PERMIT REPORT

To: Board of Managers

From: Heidi Quinn, Permitting Technician

Re: Permit 19-661: Wassermann Park, Victoria- Phase I Boardwalks & Exception Request for Phases I & II

WETLAND BUFFER EXHIBIT

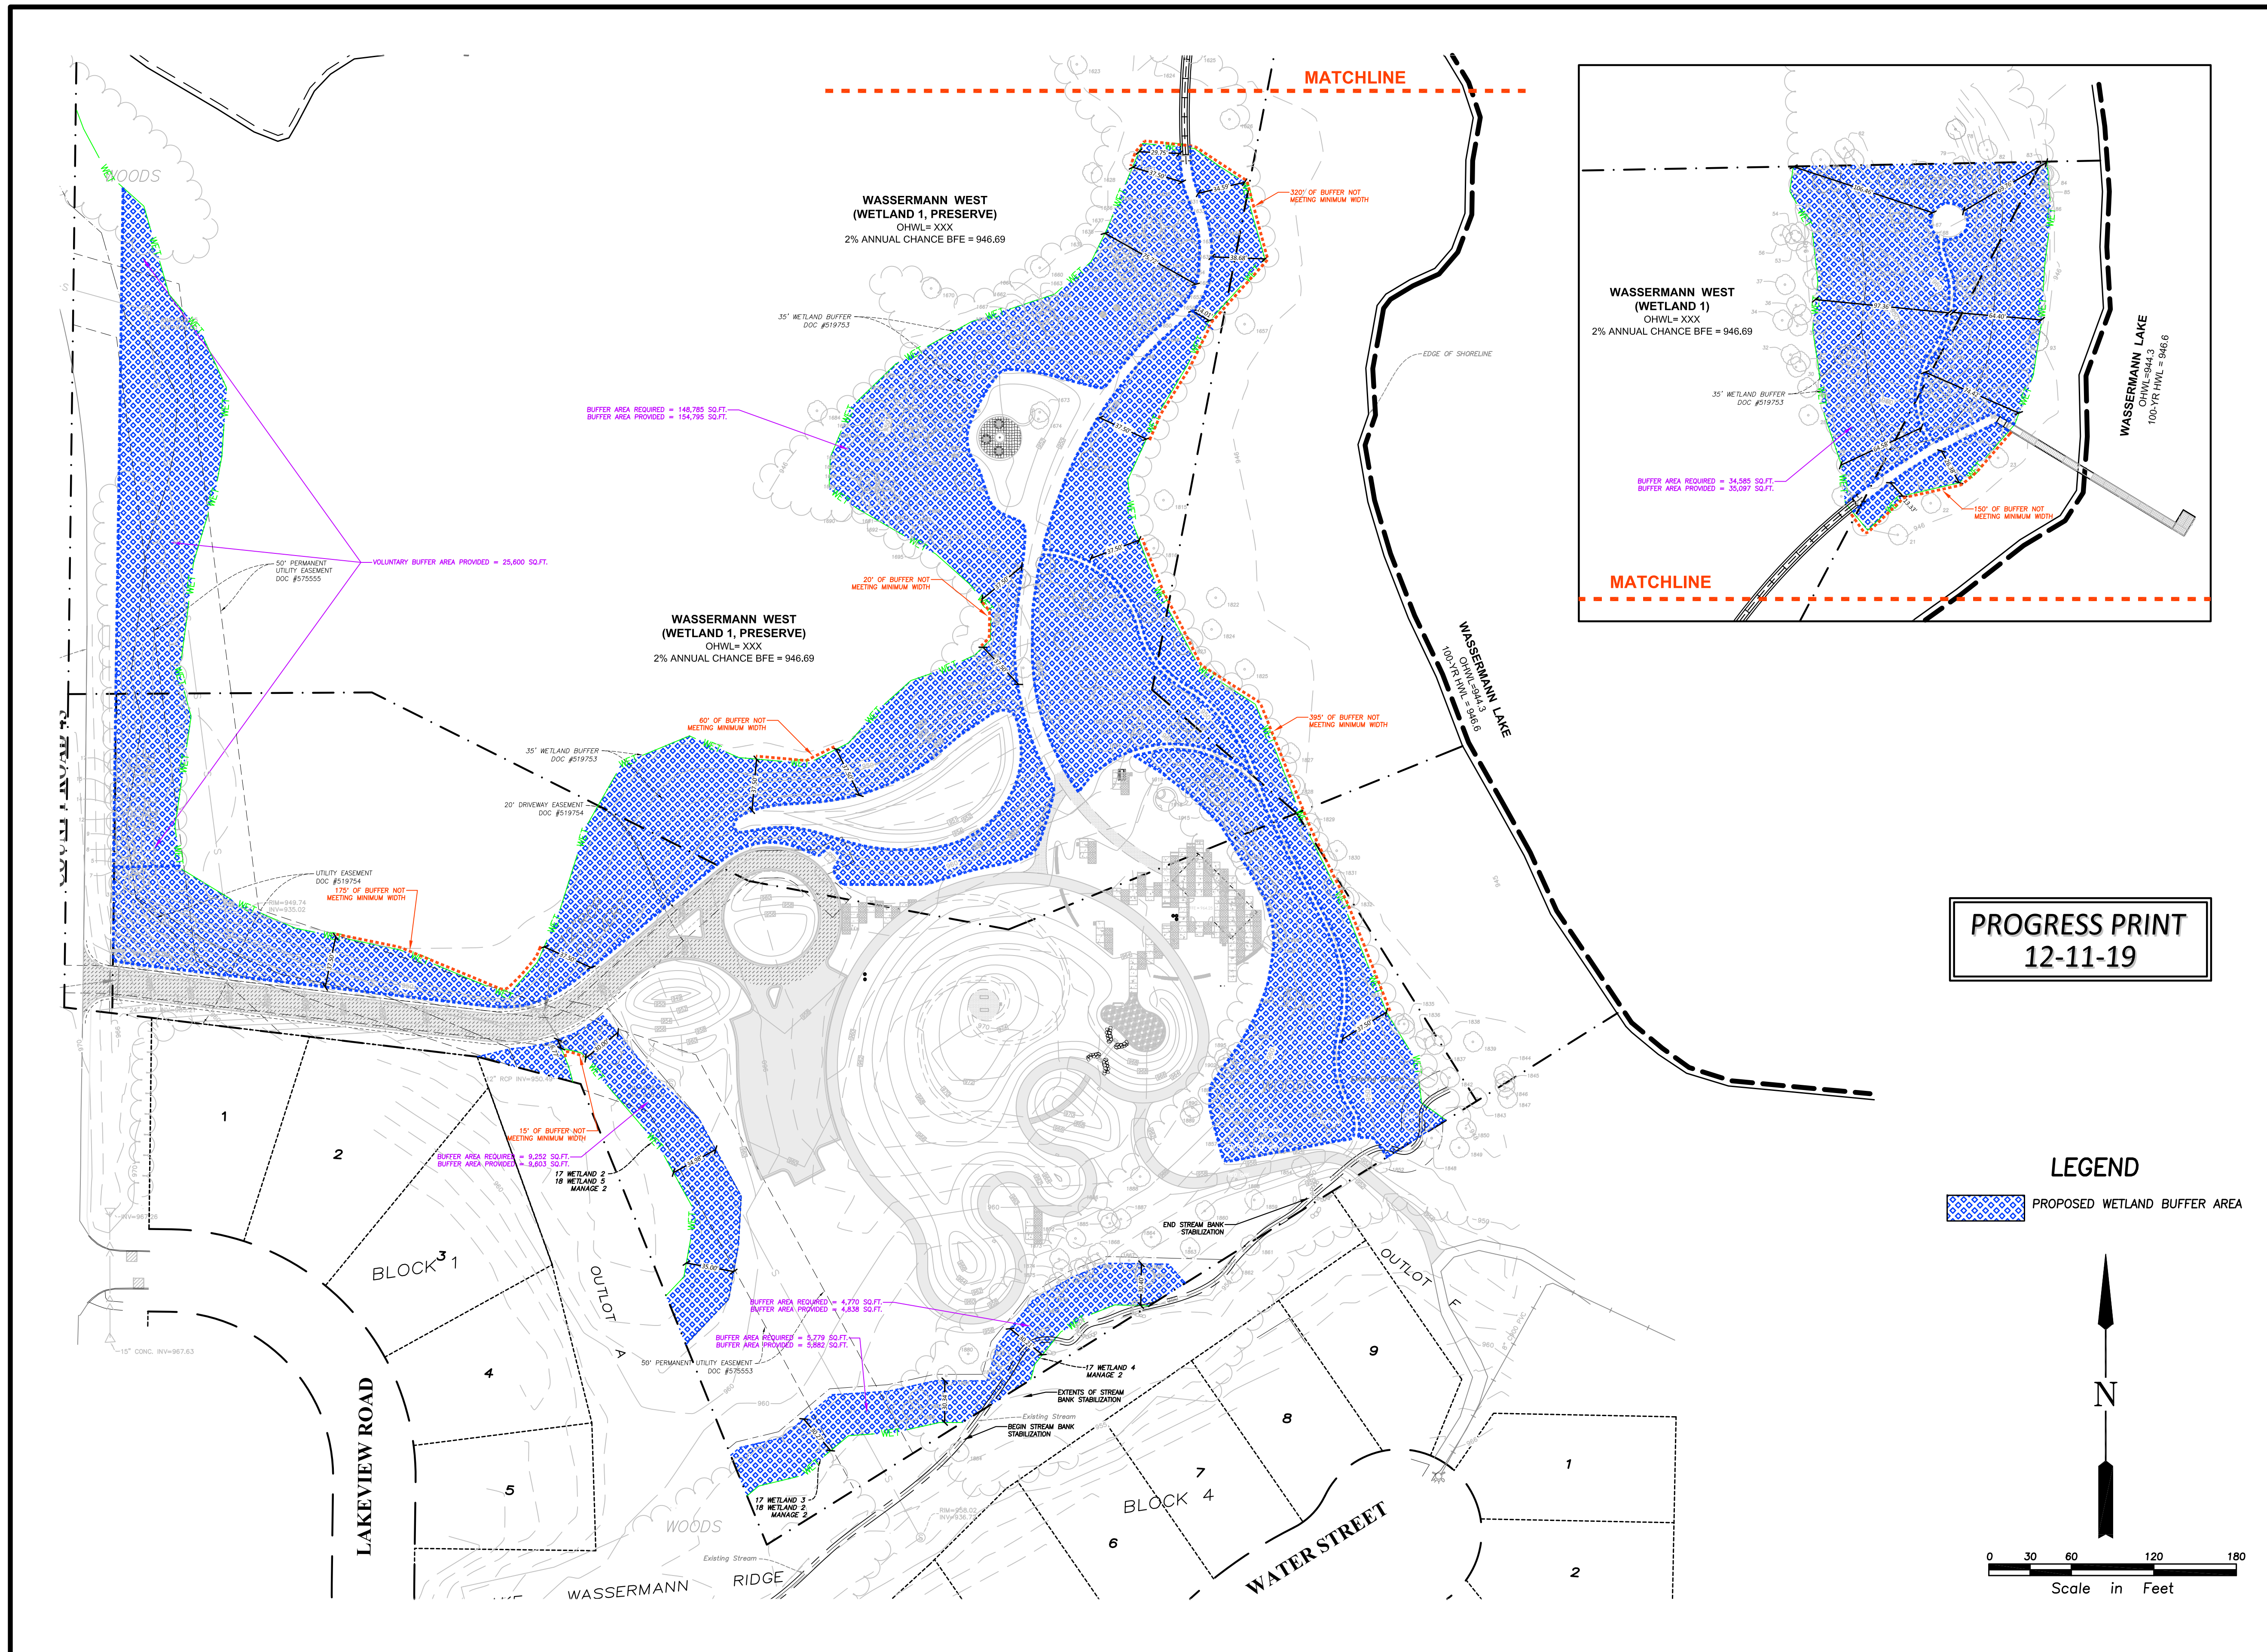
The Applicant has provided a plan that demonstrates that there are several locations that the minimum buffer width is not provided due to the future location of trails, a stormwater filtration basin, and a road expansion to meet safety standards. Based on Staff’s review of the proposed wetland buffer exhibit, which is representative of the buffer requirements for both of the project phases, there are six segments within the project in which the minimum buffer width is not maintained at all locations for Wetland 1 and one segment within the project in which the minimum buffer width is not maintained at all locations for Wetland 2. Table 2 below summarizes the average shortfall from the required minimum buffer width for the six segments of Wetland 1, a Preserve wetland.

Segment	Linear Feet of Segment	Average Minimum Buffer Width Provided (ft)	Average Shortfall from Required Minimum Buffer Width of 37.5 (ft)
1	175	27.5	10
2	60	33	4.5
3	20	21.75	15.75
4	320	27.5	10
5	395	22.5	15
6	150	22	15.5

For Wetland 2, a Manage 2 wetland, an averaged minimum buffer width of 9.75 feet is provided for 15 linear feet which is 5.25 foot shortfall from the required minimum width of 15 feet. Table 3 below

Wetland #	Size of Wetland	Management Class	Base Buffer Width	Required Minimum Buffer Width	Required Buffer Area	Provided Buffer Area	Linear Feet Not Meeting Minimum Buffer Width Requirement	Area of Minimum Buffer Width Not Met
1	23.21 ac	Preserve	75'	37.5'	4.00 ac (174,385) sf	3.55 ac (154,795 sf)	1,090	0.34 ac
2	0.18 ac	Manage 2	30'	15'	0.21 ac (9,252 sf)	0.22 ac (9,603 sf)	15	79 sf

The wetland buffer provision per section 6(c) of the Wetland Protection Rule is intended to provide water quality treatment to stormwater runoff prior to entering a waterbody and to provide habitat adjacent to waterbodies. The Applicant has provided a detailed exception application that demonstrates a plan for a restoration project with the goals of water quality treatment and habitat restoration. The Wasserman Park master plan involves vegetation restoration across three ecosystems (1.56 acres of prairie, 2.14 acres of wetland, and 1.62 acres of oak savannah), provides wetland buffers to the greatest extent feasible, avoids impacts to wetlands, proposes 370 feet of stream channel restoration, and will treat approximately 0.13 acres of impervious surface that would be exempt under the District’s linear reconstruction provisions of the Stormwater Management Rule. In addition to the proposed improvements, the Applicant has completed an alum treatment to the Wassermann West Pond in the Spring of 2019 that resulted in an estimated 75 pounds of phosphorous reduction annually into Wassermann Lake.

Staff and the District Engineer have reviewed the narrative and plan provided by the applicant to support the exception request and have determined that sufficient technical basis has been provided to support the exception.

In summary, Staff and the District Engineer agree that the Applicant has provided sufficient evidence that the proposed project will achieve a greater natural resource benefit, as outlined above, than strict compliance with providing the minimum buffer width in all locations around the edges of Wetland 1 and Wetland 2 per section 6(c) of the Wetland Protection Rule
